Recall 07V-142

INSTRUCTION SHEET #85490078

MODEL: FS-65, ER-HD, HDX, MVP-EF, MINOTOUR

SUBJECT: SEATBELT RETAINER STRIP

Figure 1

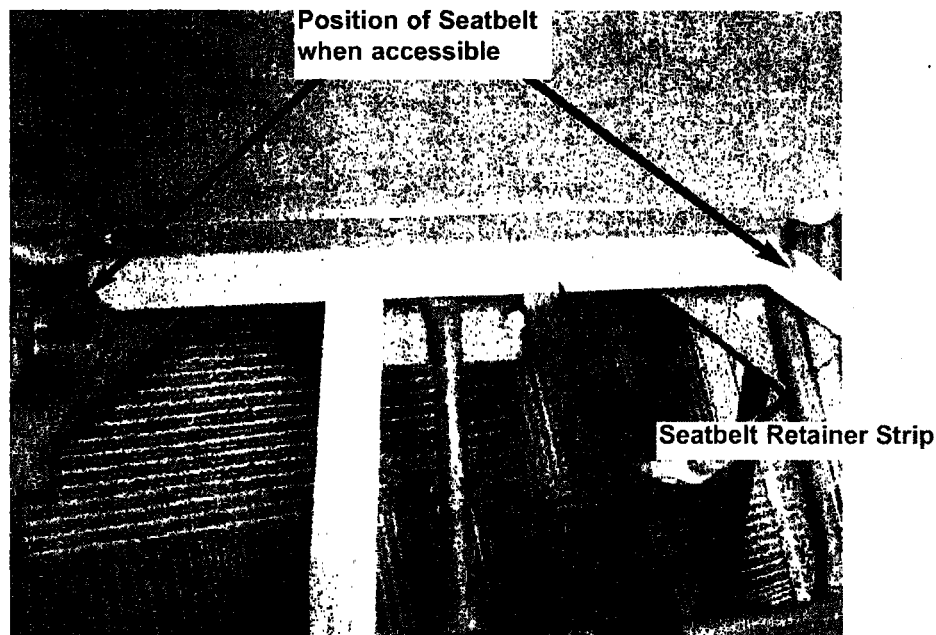
The defect involves the seat belts. The aisle side seat belt may become damaged and wear prematurely. If prematurely worn, seat belts may break which could lead to injury in certain types of accidents. Thomas Built Buses has decided to conduct this recall to ensure that the seat belts, if requested by the customers, operate properly and as expected by the customers.

1. Move seat cushion up to access the seat retainer bracket.
2. Remove the metal retainer strip and discard. Keep the existing screws.
3. Install the new plastic Seatbelt Retainer Strip, with the existing fasteners. **Figure 1**
4. Latch seat cushion back, making sure all seat belts are accessible.
5. Apply this procedure to all seats.
